Comments Received in Objection:	Applicant Comment:
<p><u>Building Size</u></p> <p>Concerns raised in regards to the building size impacting on lot boundary setbacks, street setbacks, open space and landscaping.</p>	<ul style="list-style-type: none"> • There is a minor wall setback variation proposed to Unit 3 ensuite. This will allow for improved functionality of bedroom 3. • There are no variations proposed to street setbacks. • The design choice to limit building height to a contextually sympathetic two story development has contributed to a short fall in open space, whilst better reflecting the existing neighbourhood character. • Landscaping plans have been updated to meet the requirements of LPP 7.1.1 Built Form
<p><u>Street Setback</u></p> <p>Concerns raised in regards to the impact of the street setback to Austen Lane which will create a tunnelling effect and have a negative impact on the current and evolving streetscape. The street setback provide adequate depth for vehicle parking of residents and visitors.</p>	<ul style="list-style-type: none"> • The building has been designed with articulation to achieve a reduction in building bulk as viewed from the street. All street s

B99 VEHICLE – SINGLE SWEEP PATH

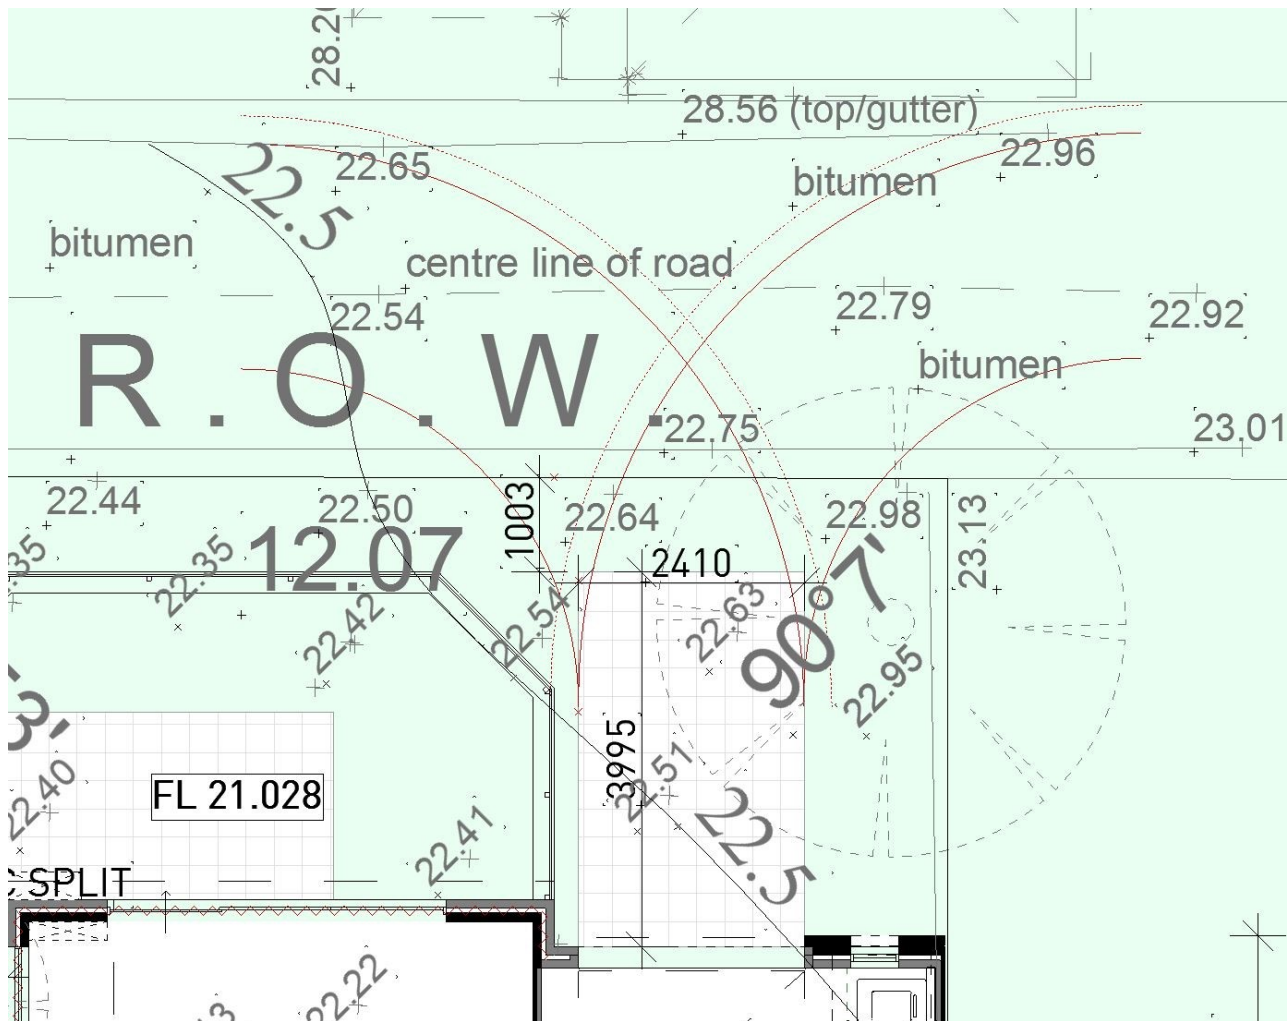
Comments Received in Objection:	Applicant Comment:
<p><u>Car Parking</u></p> <p>Concerns raised in regards to the impact of car parking on Austen Lane.</p>	<ul style="list-style-type: none"> • The R-Codes require 6 bays for residents and 1 bay for visitors. The current plans propose 7 car bays in total. We have also allowed for four bicycle bays in lieu of the three required by the R-Codes. • The lot is approx. 1000m from the Leederville train station. It is also in close proximity to high frequency bus routes, approximately 600m from Charles Street and 750m from Scarborough Beach Road.
<p><u>General Comments</u></p> <p>Concerns raised in regards to the rear laneway being narrow for vehicle access of Unit 4 and the potential to damage the adjoining property of No. 3 Austen Lane. Vehicle access can be proposed to Austen Lane;</p> <p>Will a dilapidation report be provided; and</p> <p>What type of fence/wall will be erected around the perimeter of the property?</p>	<ul style="list-style-type: none"> • I have included a diagram of a single sweep path for B85 and B99 vehicles. This is with the bitumen in its current location. There will be enough room to manoeuvre any vehicle using a three point turn if necessary, which is in compliance with AS2890.1 • If a dilapidation report is a requirement of planning approval it can be provided, otherwise there is no intention to provide one as vehicle manoeuvring is in compliance with AS2890.1 • There is a brick fence with aluminium slats proposed to street elevations, and colorbond fencing proposed between the lot boundaries where there is no boundary wall.
